Agenda Item: Administrative Amendment – Change in Conditions – Carotek

DATE: February 17, 2017

ADMINISTRATIVE AMENDMENT Carotek Expansion Building

Re: Administrative Zoning Approval for
Carotek Manufacturing Building Expansion #2
700 Sam Newell Rd.
Matthews, NC 28105
TP#193-292-01

SITE AND LANDSCAPE PLAN
CAROTEK BUILDING EXPANSION #2
710 SAM NEWELL ROAD
MATTHEWS, NC 28106

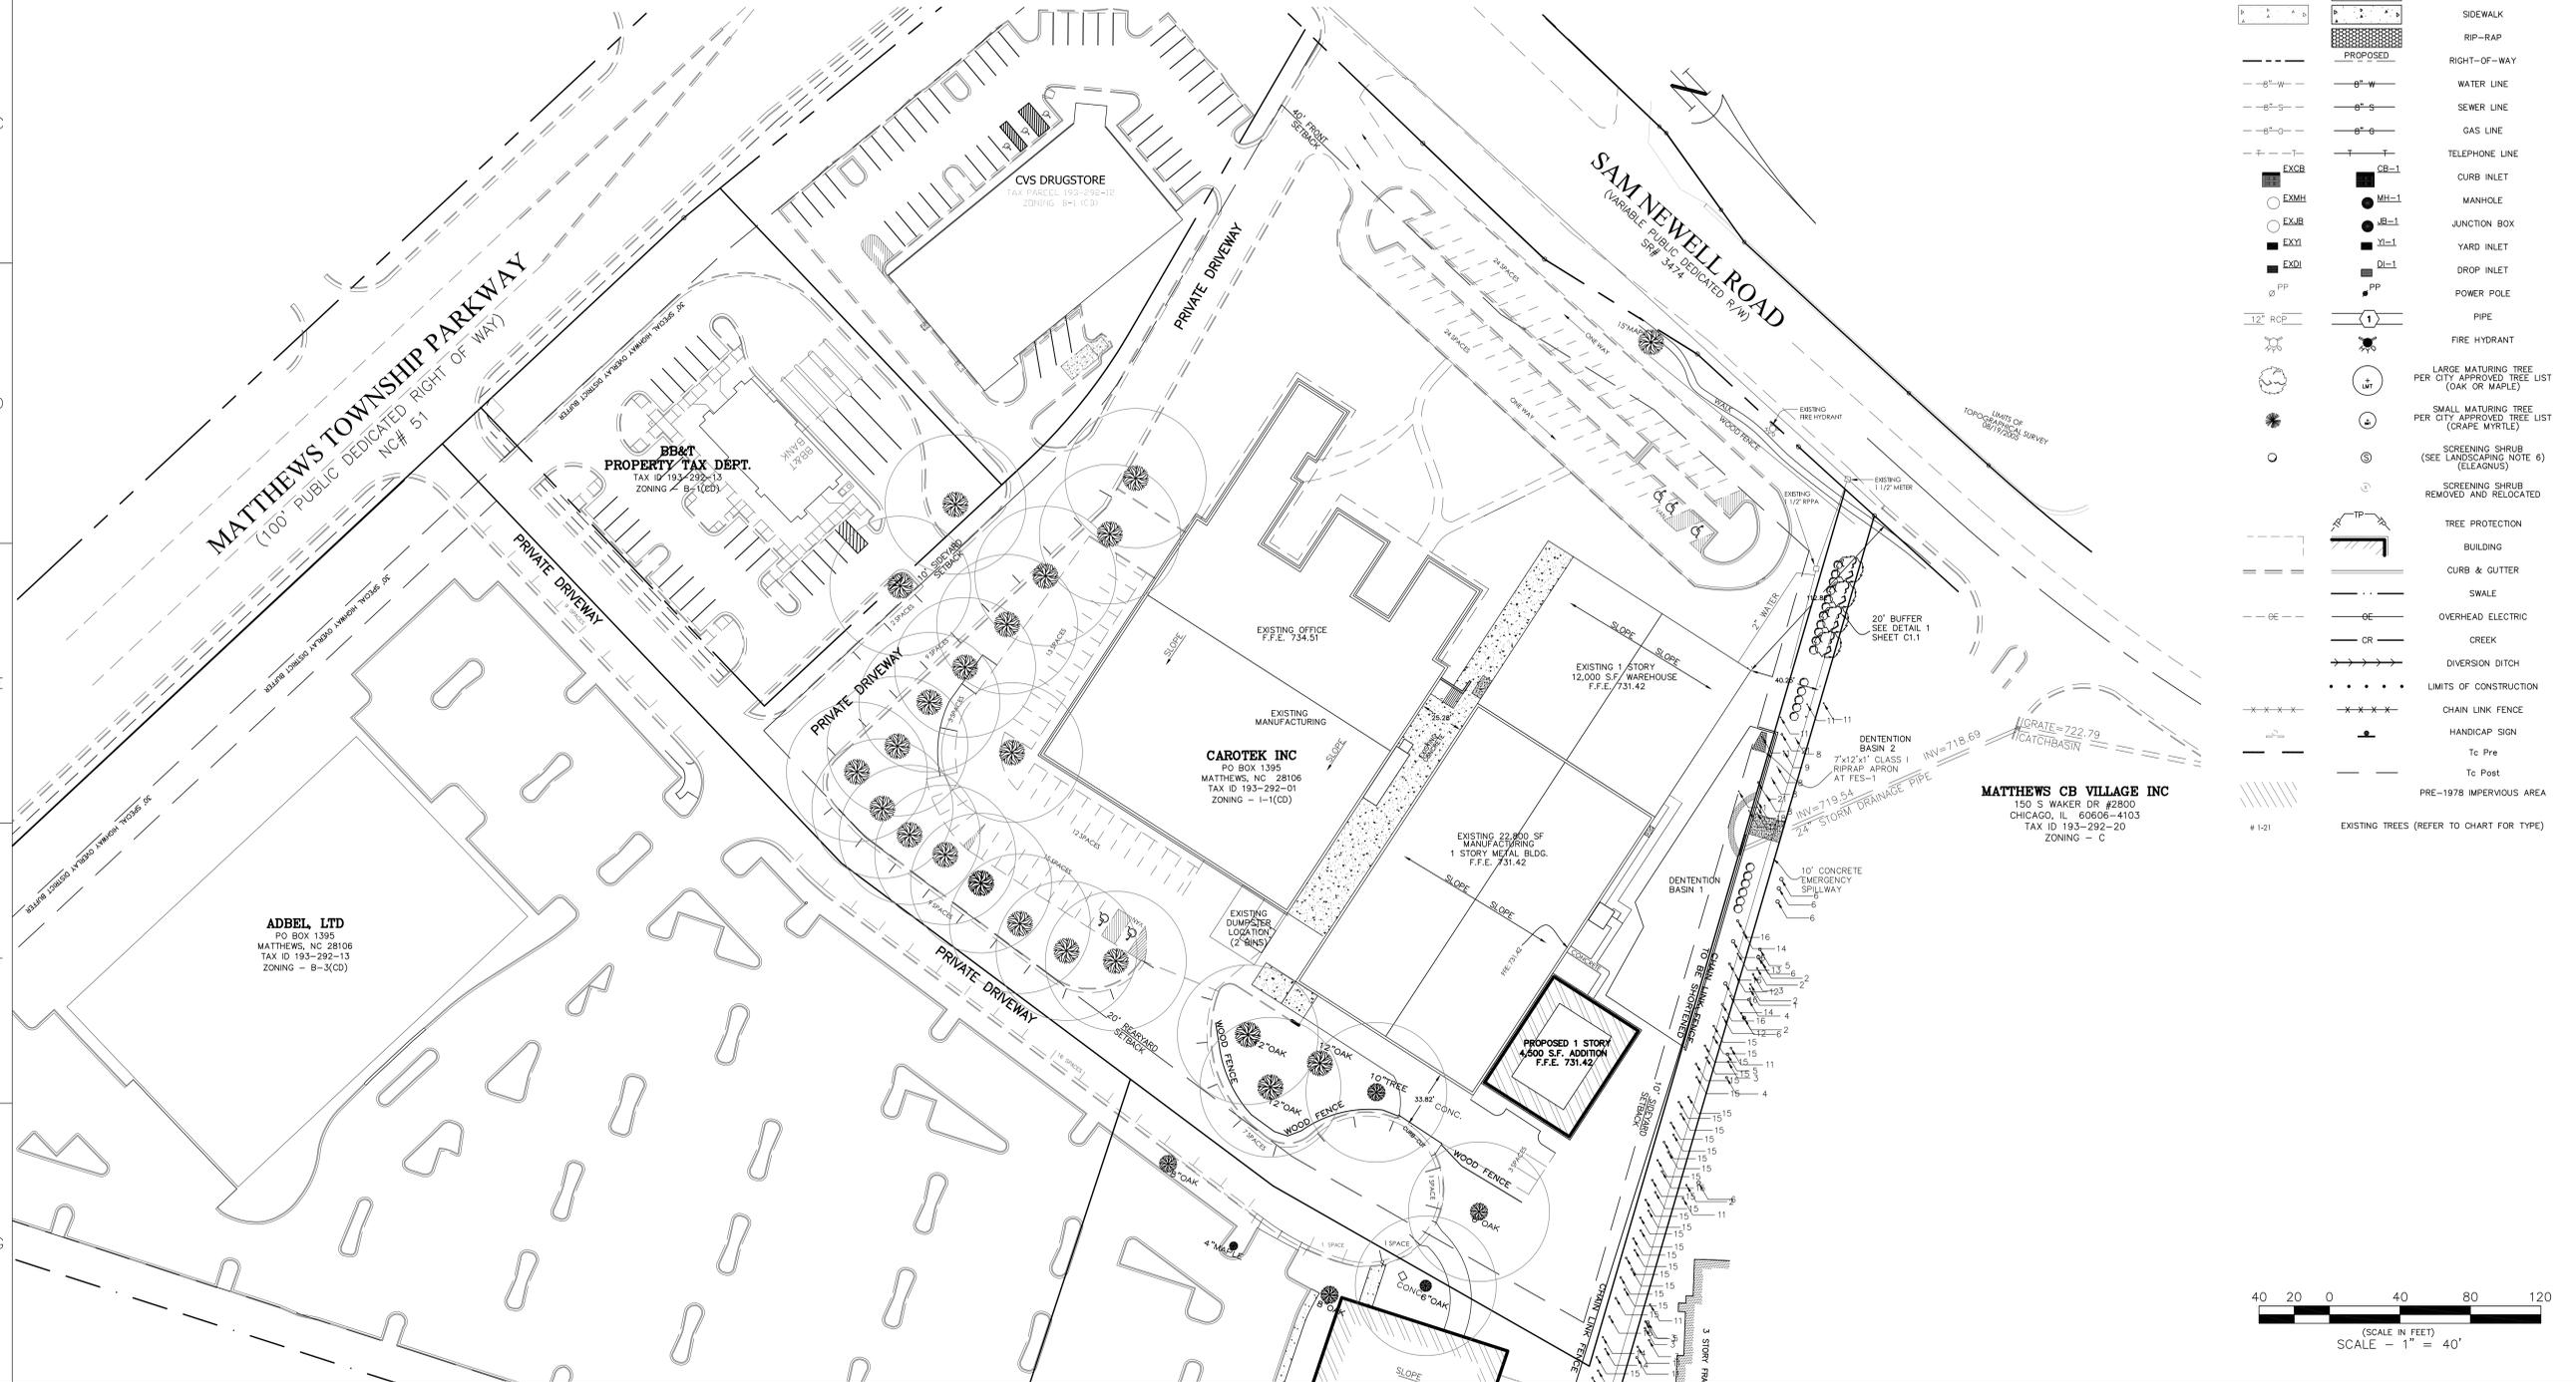
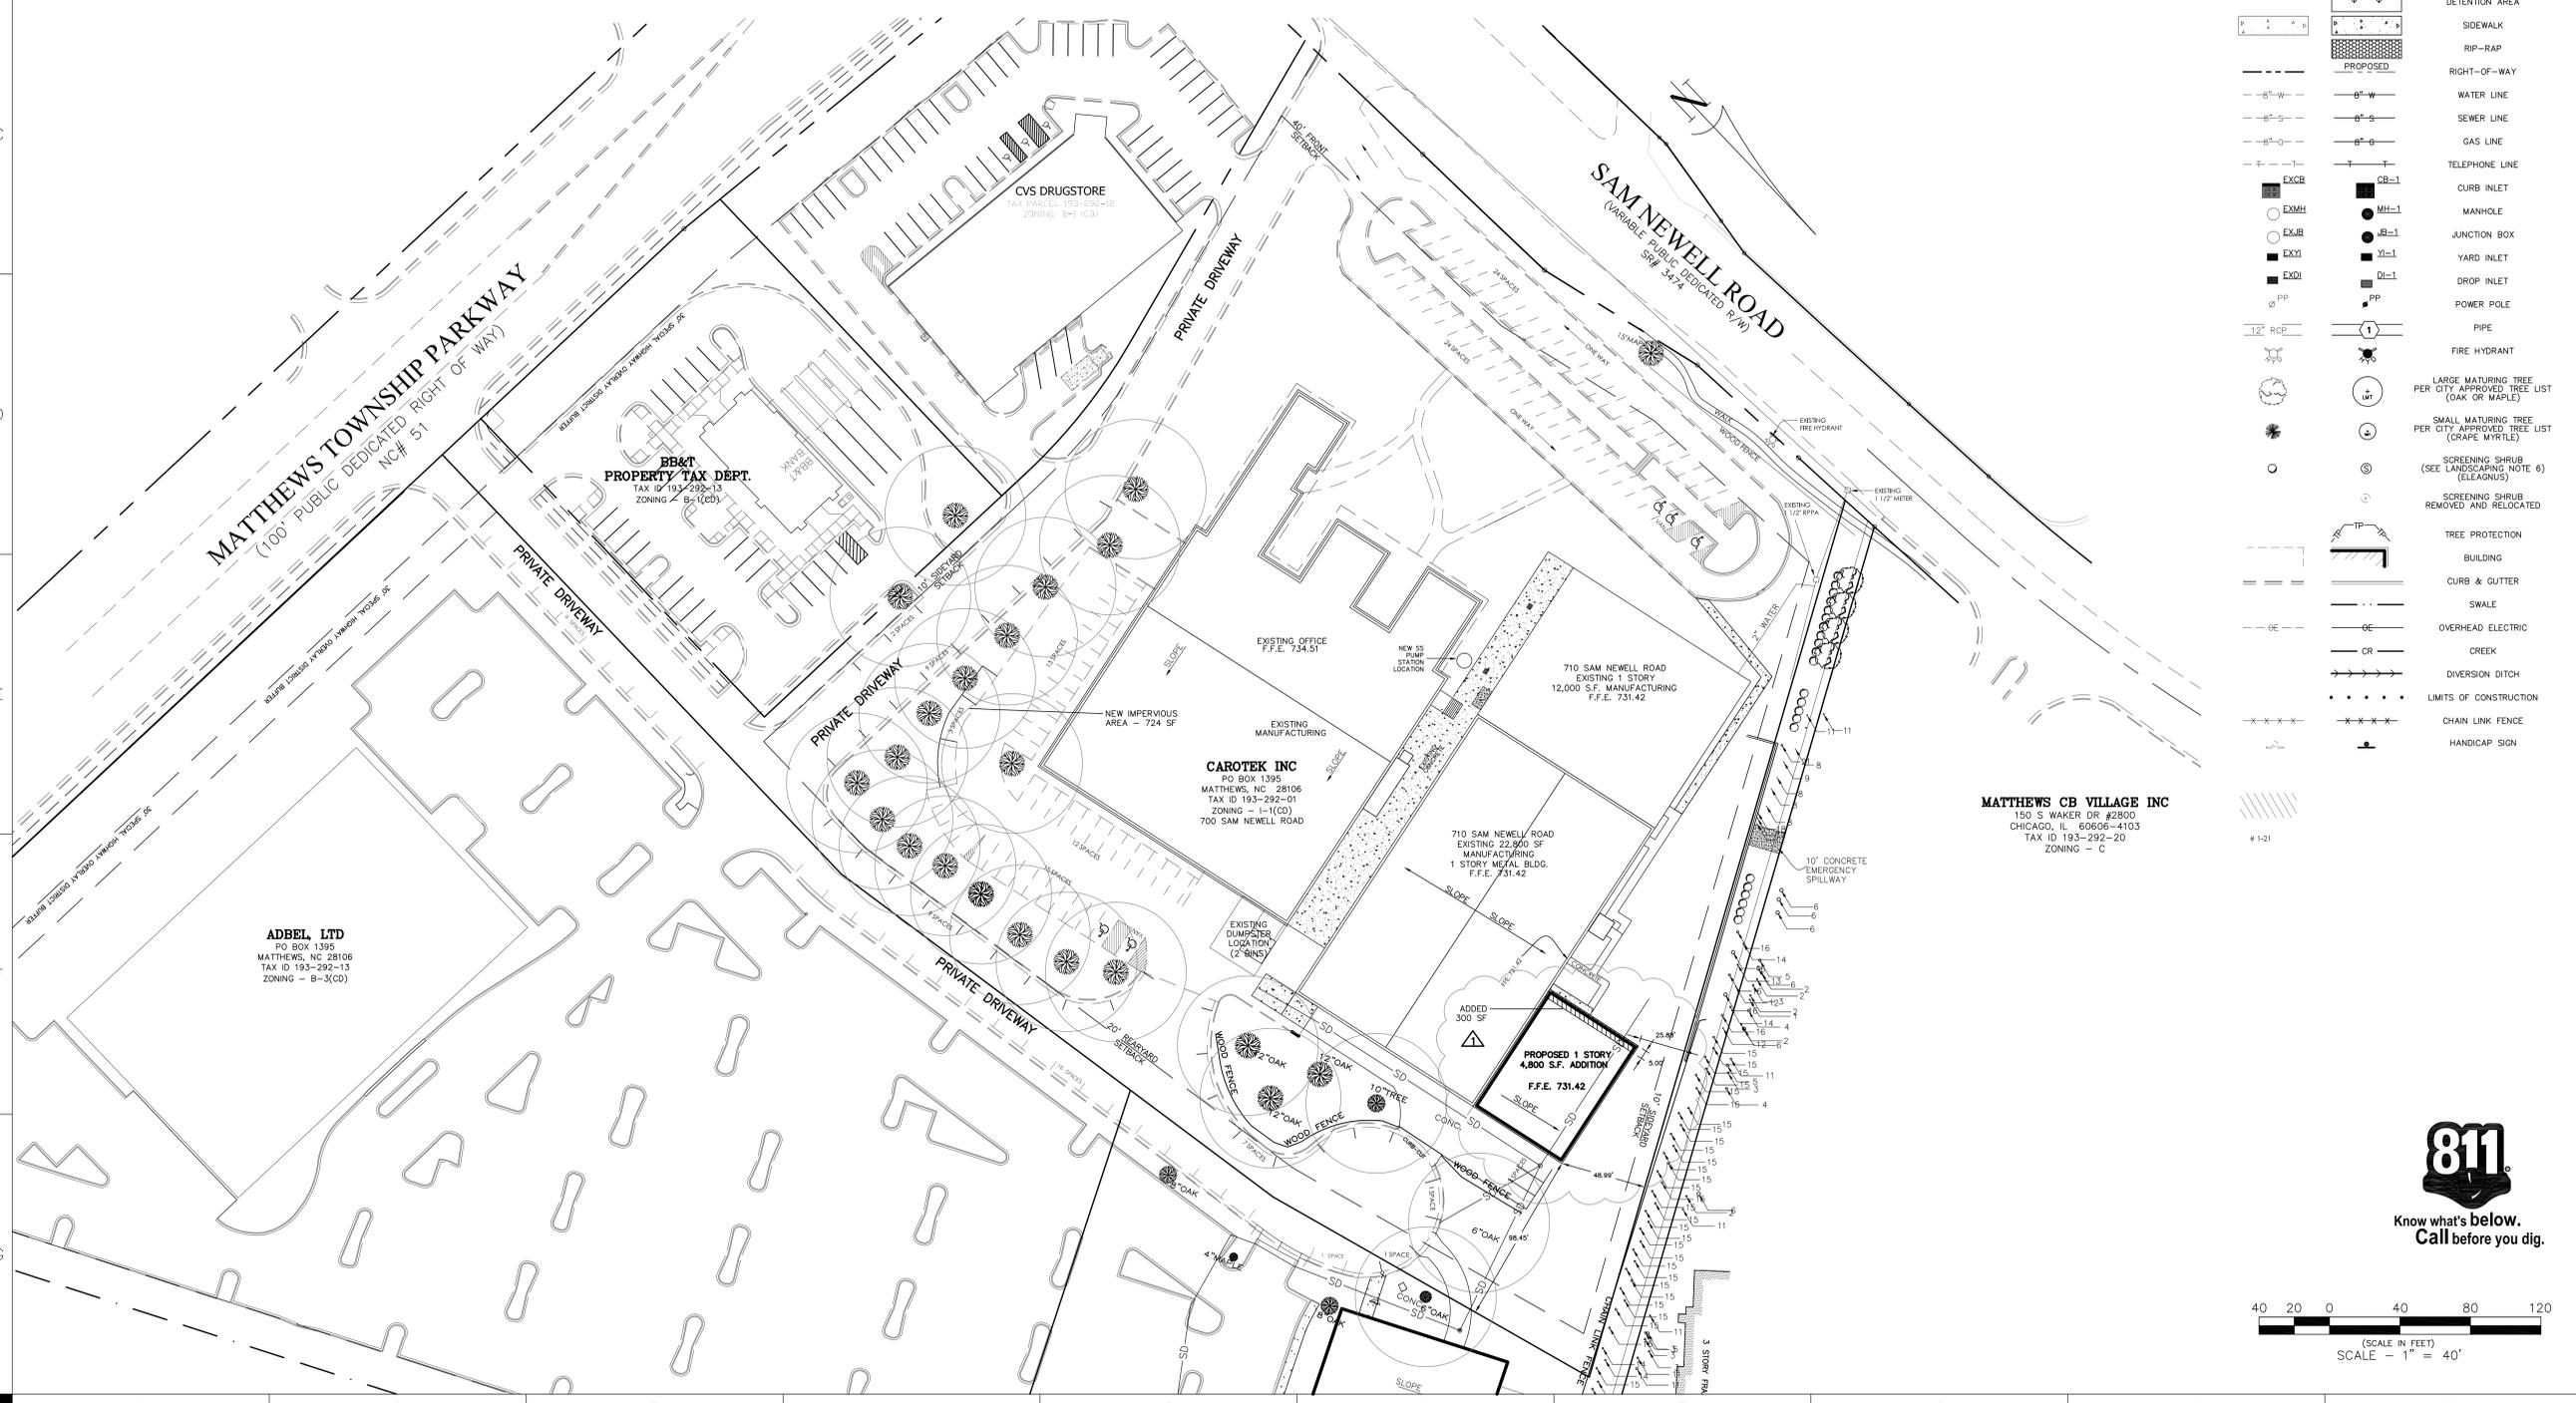
Carotek is now requesting an additional 300 square feet for the previously approved building. The addition would provide a total of 4,800 sq ft. With the additional square footage, they have to move the structure forward in order to keep out of the existing detention pond on site. Parking modifications and additions that were approved in October 2016 are not changing with this request. Attached are the Administrative Amendment request letter, approved site plan from October 2016 and proposed site plan changes.

- A. Increase the structure for a total of 4,800 sq ft for manufacturing storage.
- B. Move the new structure forward to be in-line with the existing structure.

Mr. Deryl Bell, President of Carotek, requests an administrative zoning approval for the proposed expansion of the manufacturing building located at 700 Sam Newell Rd. and further described at tax parcel 193-292-01. In October 2016, we requested and received approval for a 4500 sf building. However, required elements, inside the building, has precipitated an increased in the building size to 4800 sf. The building is still in located along the north side of existing manufacturing building. The purpose for the expansion is still to free up existing manufacturing space by the relocation of large spare parts that are used in the manufacturing process. Again, this will free up needed space to manufacture larger process assemblies. The request for administrative approval is consistent with the existing zoning of I-1 (CD) and the use will remain the same. The material of the outside of the proposed addition will be anodized aluminum and the color will match as close as possible to the existing building. The height of the proposed addition will be 26-1/2 feet at the eve and 29 feet where it meets the existing building. The eve of the existing building is 30 feet. The parking requirement is 109 spaces and we have 123 spaces available; therefore, no new parking spaces will be created. The increase to the existing impervious area will be approximately 1473 sf.

REV	DATE	COMMENT	BY
10/12		ISSUED FOR ZONING REVIEW	TCW
02/18		INCREASED SIZE OF BUILDING	TCW
11/17
